Item Name: Middle, Center Ceiling Replacement Panel Assembly

WORK ORDER NON-CONFORMANCE / UPDATE

From: Eric Downing
Sent: Tuesday, December 24, 2013 8:06 AM
To: David Shepherd; Linda Lacelle
Cc: Patrick Smith; Nigel Forbes; Daryl Leger
Subject: D4634-143/-141

D4634-143 MIDDLE, CENTER CEILING REPLACEMENT PANEL ASSY

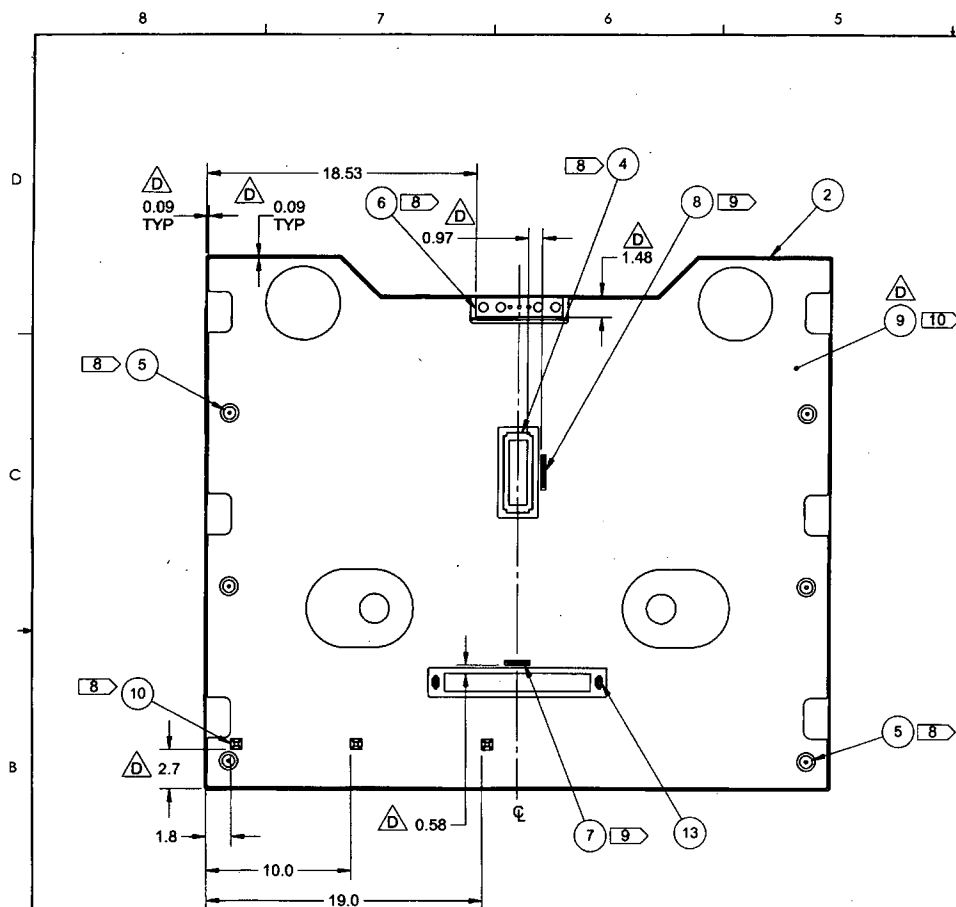
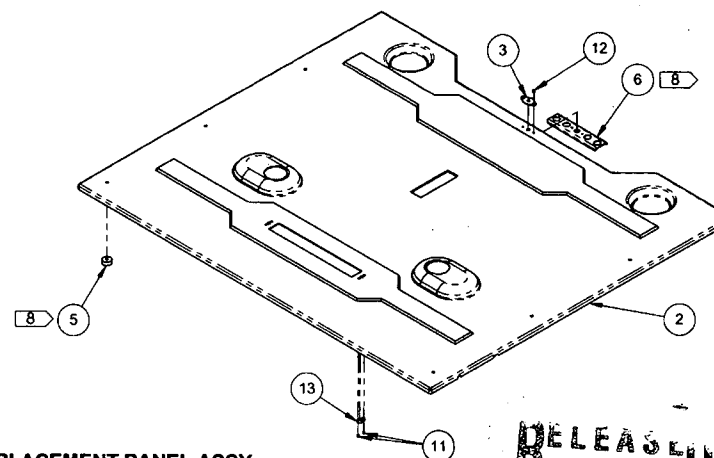
Root Cause	Date	Step	Qty	Description of work order update or non-conformance	Initial Chief Eng	Action Description	Sign & Date	Verification	QC Inspector
Design				Wrong D4712-1 Doubler.	S	Acceptable this time with	DL		
Doc/Data				was bonded to the Panel	13/12/24	Per Attached E-mail from	13/12/24		
Equip/Tooling				employee used Rev B not	Per Attached	Transfer Drill 0.129" hole			
Handling/Pre				Rev C	Email From	Deburr and			
Material	13/12/24	100	x1	RC Employee pulled from	David	Tough up closer as per			
Operator				Stores. older Rev Parts. Piece	Shepherd	Q2003			
Offset/Setup				to any change (Demin/ELAS)					
Process				being Reborn					
Supplier									
Training									
Transport									
Unapproved

We have found our first little hiccup on the interiors this morning. Daryl pulled D4712-1 Rev B from stores and bonded it into place. On D4634-143 & D4334-141

The only changes I can see are the size of the holes. The rev b part have a 0.098" hole and the rev c has a 0.129" hole other than that I don't see any other changes in the two rev's.

To make it work the 0.098" holes will have to be transferred drilled, deburred, and touched up neatly with alodine as per QSI 005.

This is acceptable.
